PLAN COMMISSION PC #23-011
2201 N Chestnut Townhomes
315 W Rand Road & 2201 N Chestnut Ave
Round 3 Preliminary Plat

Planning & Community Development Dept. Review

Project: 2201 N Chestnut Townhomes
2201 N Chestnut Ave, 315 W. Rand Rd.

Case Number: PC 23-011

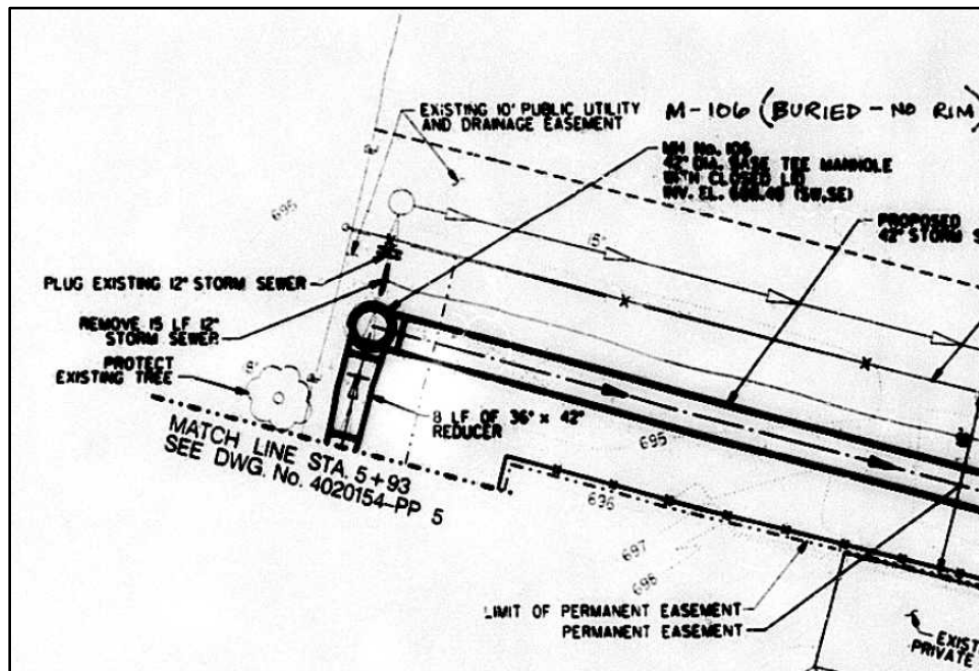
- b) The proposed bioswales to address the area that currently sheet drains to Rand Road is acceptable.
 - c) The 2002 as-builts from the Rand-Palatine Stormwater Management Phase I for the Central Detention Basin were provided, it appears the plans still do not accurately show the existing storm sewer. An image of the as-builts is below.

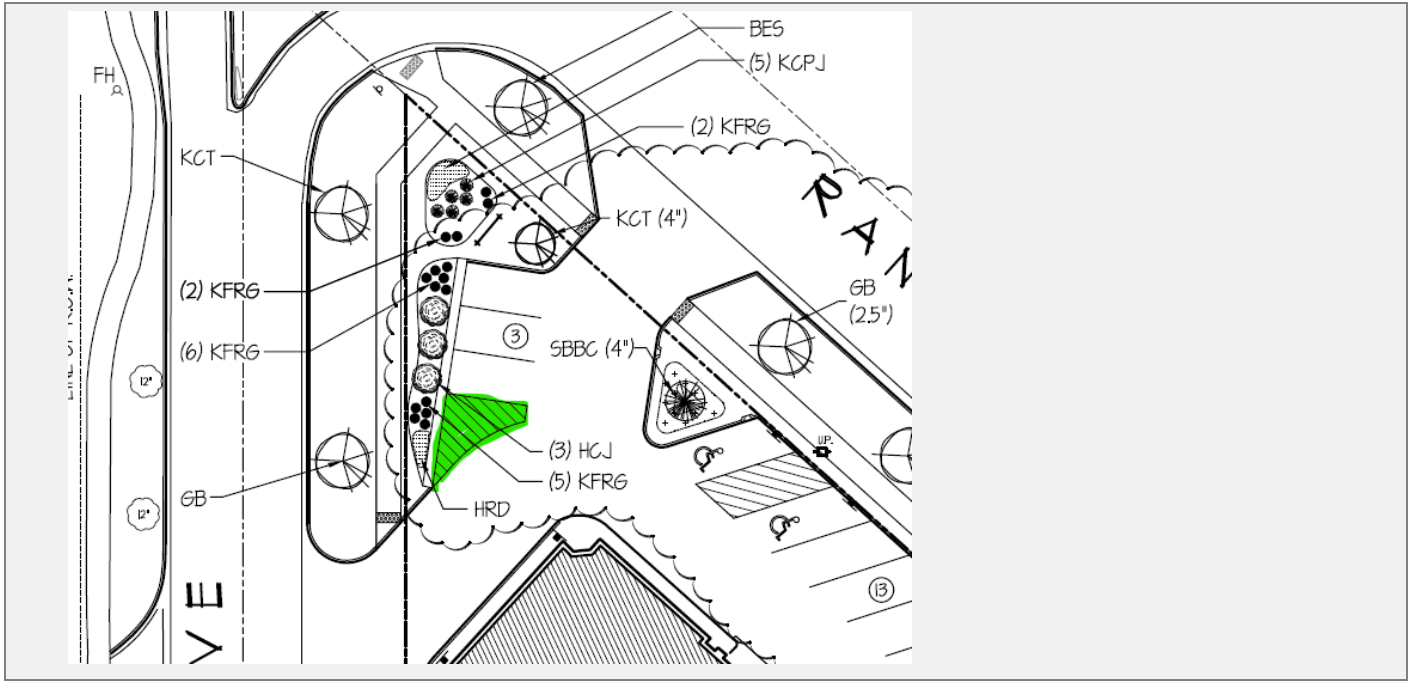
55. The striped area near the entrance off of Chestnut should be converted into a landscape island (see next page).
